Re: Interpretation for SEA 2005-SU-007, Korean Central Presbyterian Church Trustees,
Tax Map 64-2 ((13)) 18; 64-2 ((5)) 1, 2, 3; Landscaping, Fencing, Parking, Bridge, Sign

**Subject: Korean Central Presbyterian Church
Special Exception Amendment: SEA2005-SU-007
Site Plan: 9630-SP-004-2
Letter of Interpretation for Landscaping and Fencing Adjustments
Comment Response**

**Subject: Korean Central Presbyterian Church
Special Exception Amendment: SEA2005-SU-007
Site Plan: 9630-SP-004-2
Addendum to Letter of Interpretation for Landscaping and Fencing Adjustments
date February 11, 2010**

KOREAN CENTRAL PRESBYTERIAN CHURCH
 SULLY DISTRICT
 FAIRFAX COUNTY, VIRGINIA
LANDSCAPE RELOCATION EXHIBIT - REVISED LAYOUT

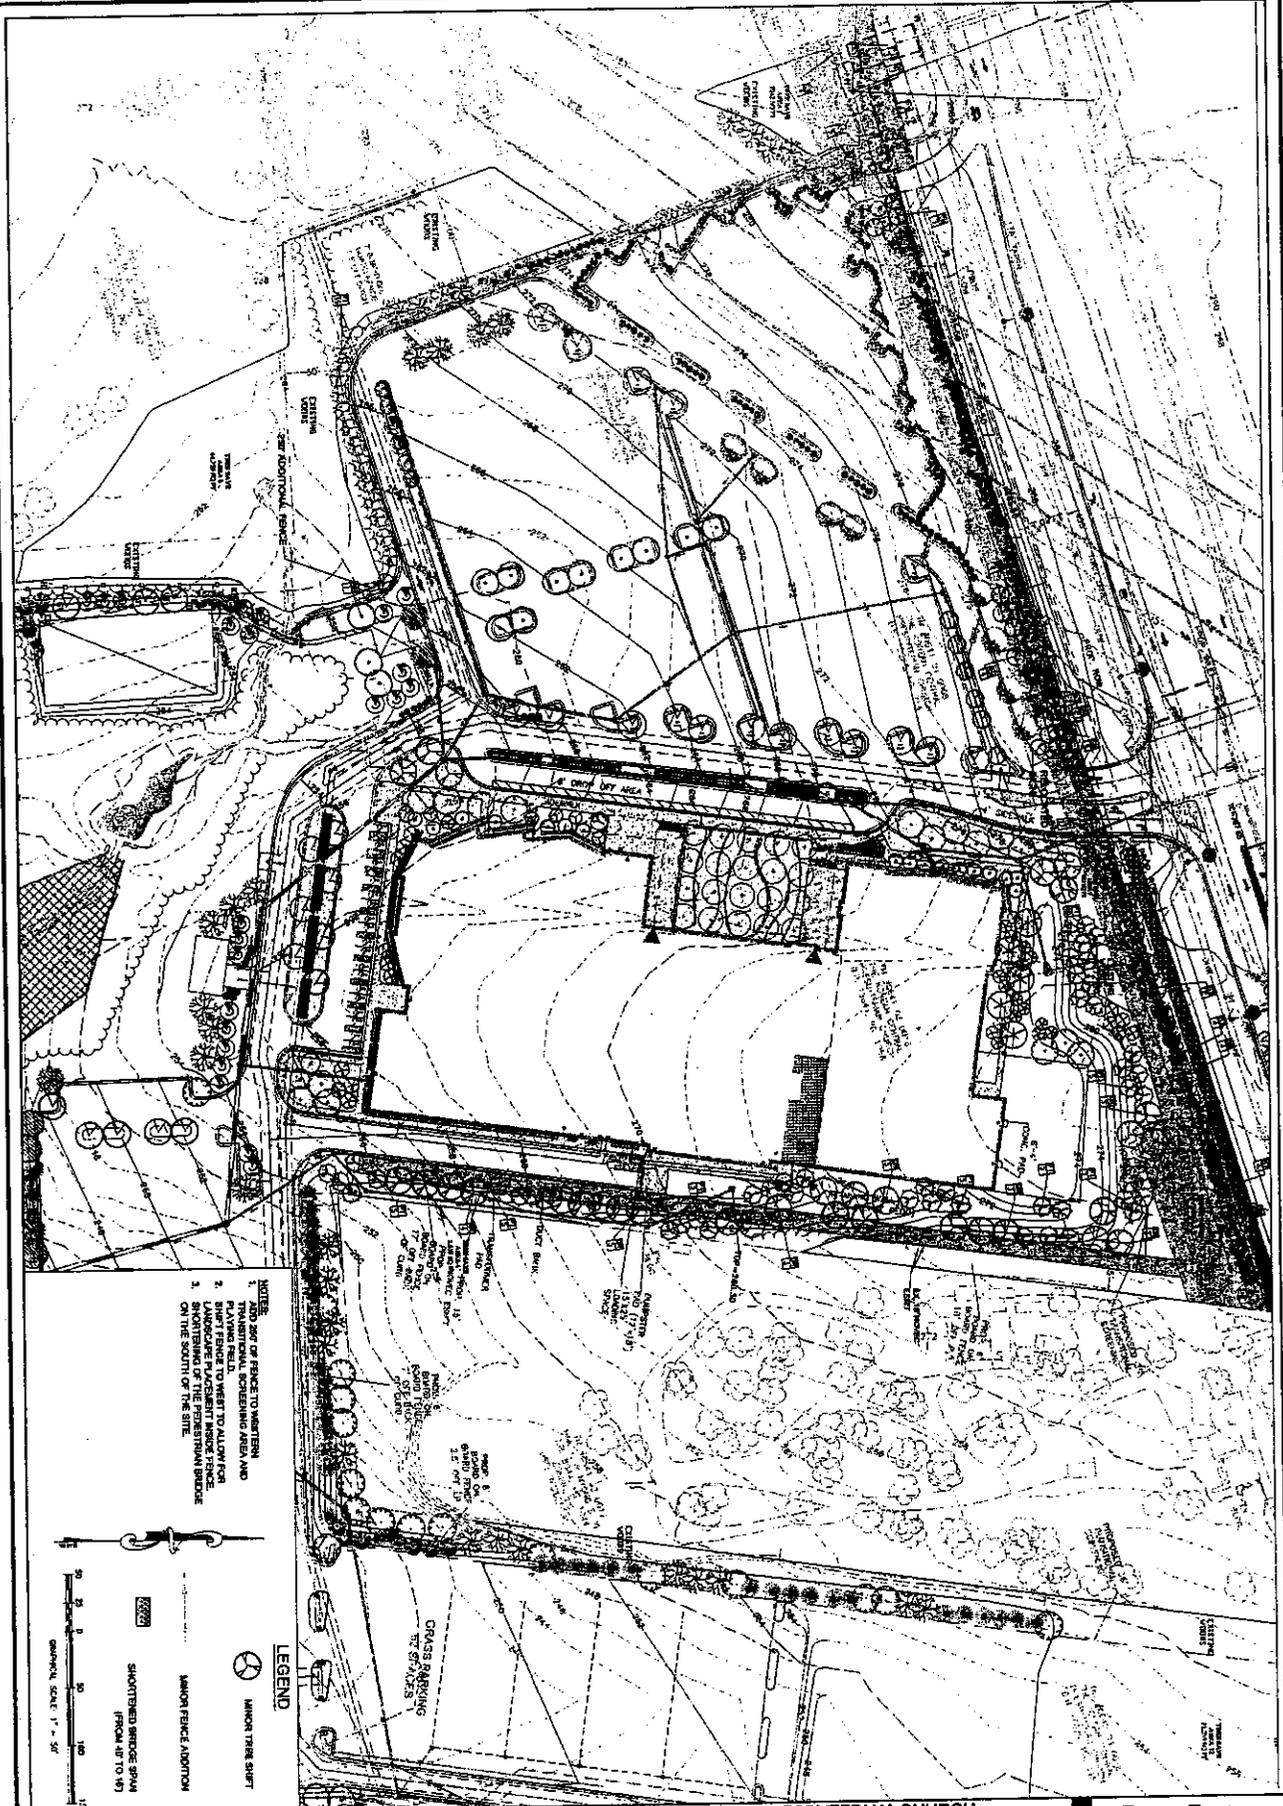
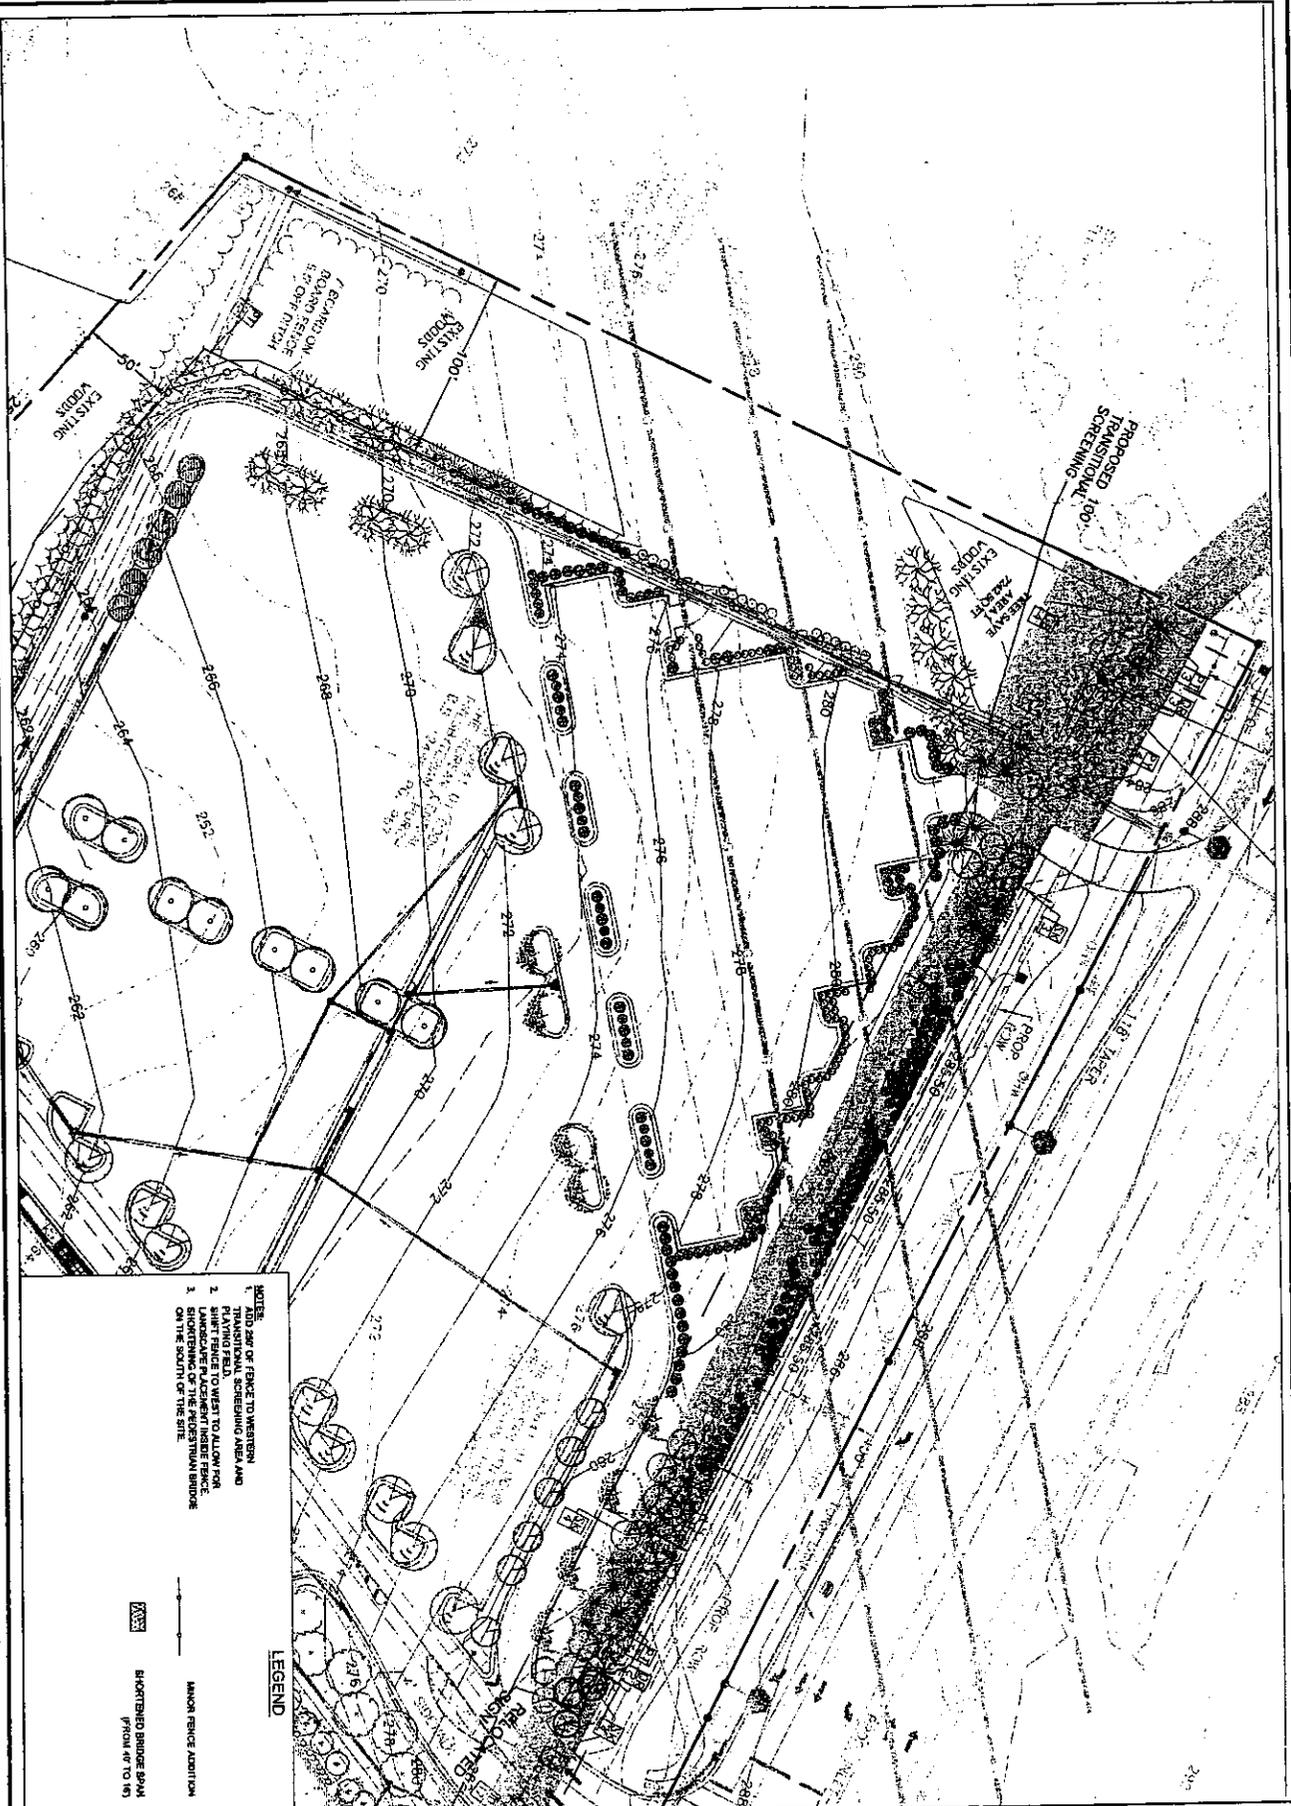
1. **Relocate Trees to Southwest** – This request is being withdrawn. The trees that were to be relocated have been planted in accordance with the approved site plans and Special Exception.
2. **Fence Location Adjustment** - The proposed fence location maintains the 100' buffer width and does not impact the tree save area. It should be noted that the landscaping required per the plans along the fence line will be planted in accordance with the approved plans. An additional plan sheet has been created to show in better detail that the fence will remain at the 100' buffer distance from the adjacent property.

3. **Modifications for NOVEC Easement** – A NOVEC easement runs parallel with the property on eastern side of the building which is used to provide underground service to the property. Some of the original plantings in this area were shown in the easement. All of the plants in this area that were in the limits of the easement have been shifted outside of the easement. Additional detail has been provided on a new plan sheet (attached). No change to the number or species of plants is proposed. This is a location adjustment only.

2. Fence Location - Your second question is whether the 7' board on board fence, which is approved to be located on the western side of the parking lot, may be shifted 6.5' to the west in order to clear a storm drainage ditch. The proposed location is shown on the submitted interpretation plan "Korean Central Presbyterian Church - Landscape Relocation Exhibit - Revised Layout," sheet 2B 2. You have confirmed that the proposed location of the fence maintains the 100 foot buffer required along the western side of the property and that the required landscaping on the western exposure of the fence will be provided. It is my determination that the proposed location of the 7' board on board fence would be in substantial conformance with the SEA Plat and development conditions.

3. NOVEC Easement - Your third question is whether the shifting of landscaping along the eastern side of the church building, in order to accommodate a NOVEC easement running 20 feet parallel to the building, would be in substantial conformance with the SEA Plat and development conditions. The plan entitled "Korean Central Presbyterian Church - Landscape Relocation Exhibit - Revised Layout," Sheet 2A of 2, provides detailed locations of the landscaping outside of the easement. The same number and quality of plantings would be provided in the shifted landscape area. It is my determination that the proposed relocation of landscaping outside the 20 foot easement is in substantial conformance with the SEA Plat and development conditions.

KOREAN CENTRAL PRESBYTERIAN CHURCH
 BULLY DISTRICT
 FAIRFAX COUNTY, VIRGINIA
 LANDSCAPE RELOCATION EXHIBIT - ORIGINAL LAYOUT

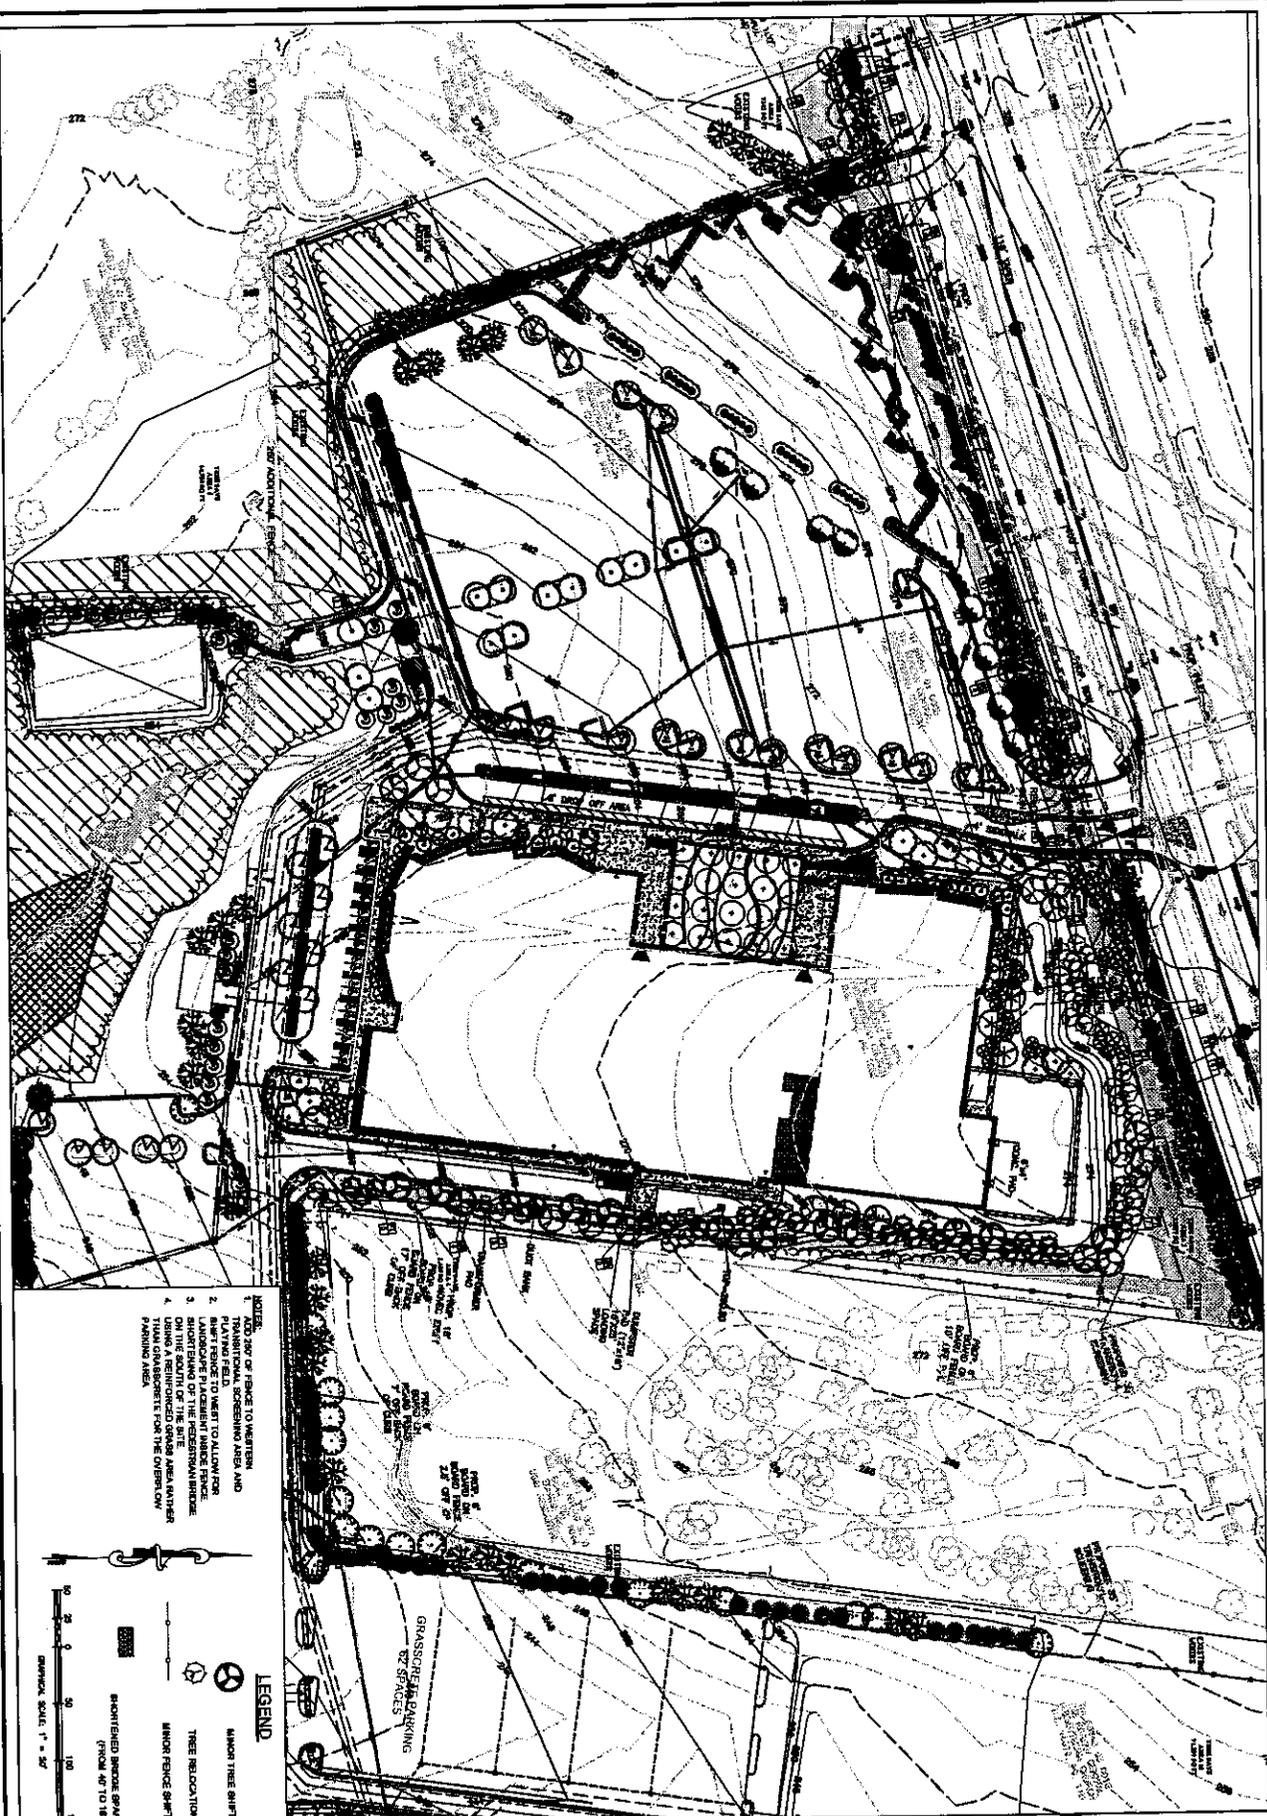
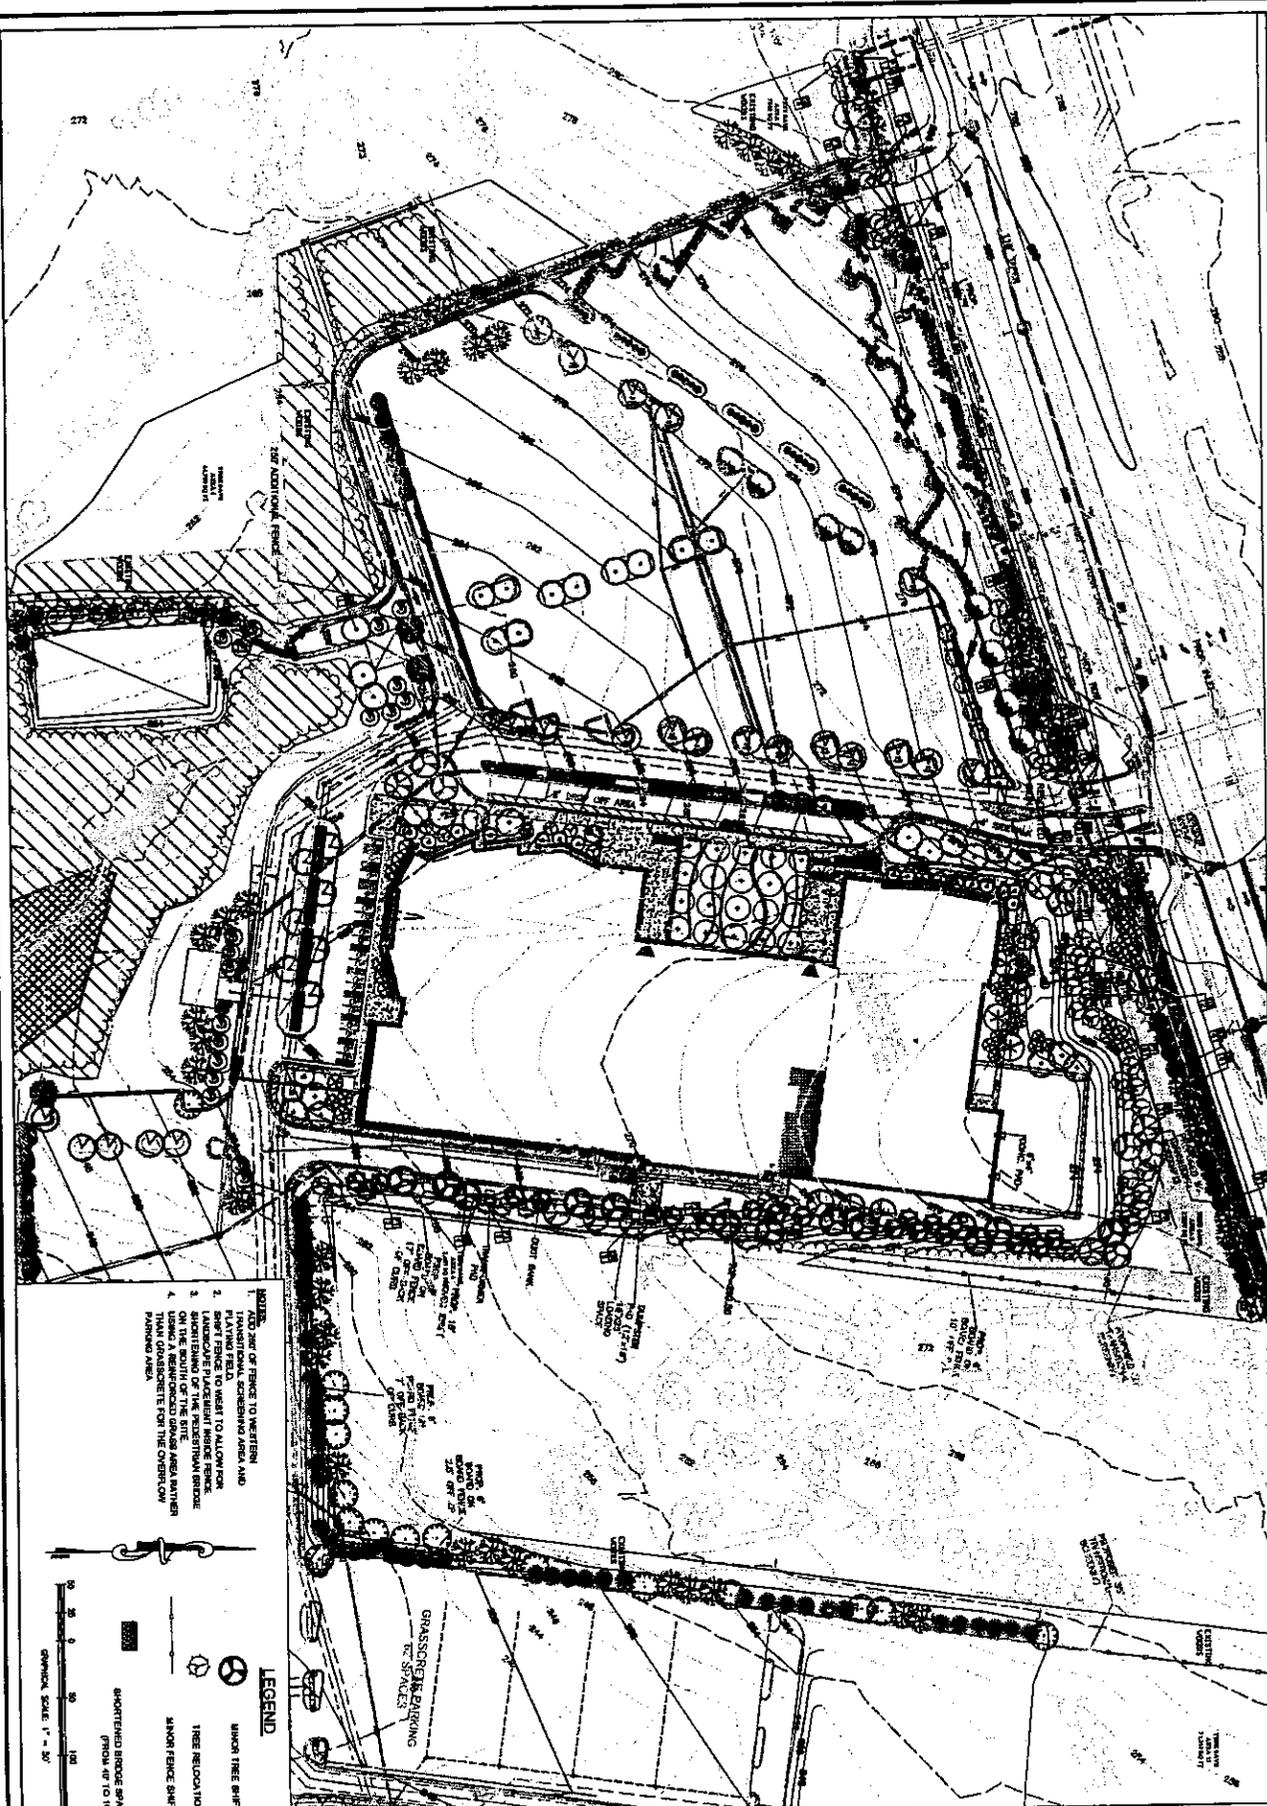
1. **Relocate Trees to Southwest** - We propose to relocate fifteen (15) evergreen trees currently shown to be planted in the low area near the proposed playground on the side of the building facing Route 29 to the southwestern property line. The owner desires to provide additional screening and noise reduction from the parking lot to satisfy neighbors' requests. These trees were originally shown in addition to the 50' Transitional Screening area plantings and were outside of the screening area. The playground area is approximately eight (8) feet below Route 29 and the adjacent property. Based upon these conditions, we feel the playground area is screened in accordance with the intent of the SE and ordinances and the relocation would improve screening in another portion of the site.

2. **Fence Location Adjustment** - The western property boundary is lined with a large stand of trees acting as a tree save area and has a 100' buffer. We are proposing to locate the fence required as part of the buffer running between the tree save area and parking lot in such a manner to allow for installation of some landscaping between the fence and the concrete drainage channel at the edge of the parking area. The proposed fence location maintains the 100' buffer width and does not impact the tree save area. Section A-A on Sheets 5 and 7 of the Special Exception Amendment indicate the location of this planting area. In addition to shifting the fence in this area, we propose to add an additional 250 feet of fence to the end of this fence to provide additional screening.

3. **Modifications for NOVEC Easement** - A NOVEC easement runs parallel with the property on eastern side of the building which is used to provide underground service to the property. Some of the original plantings in this area were shown in the easement. All of the plants in this area that were in the limits of the easement have been shifted outside of the easement.

In addition, you propose to add 250' of 7' board on board fence along the southwestern corner of the parking area and along the southern side of the parking area outside the limits of clearing and grading. You are proposing to add 15 trees inside the fence area to soften the impact of the fence for those visiting the site. It is my determination that the proposed additional fence and landscaping are in substantial conformance with the SEA Plat and development conditions.
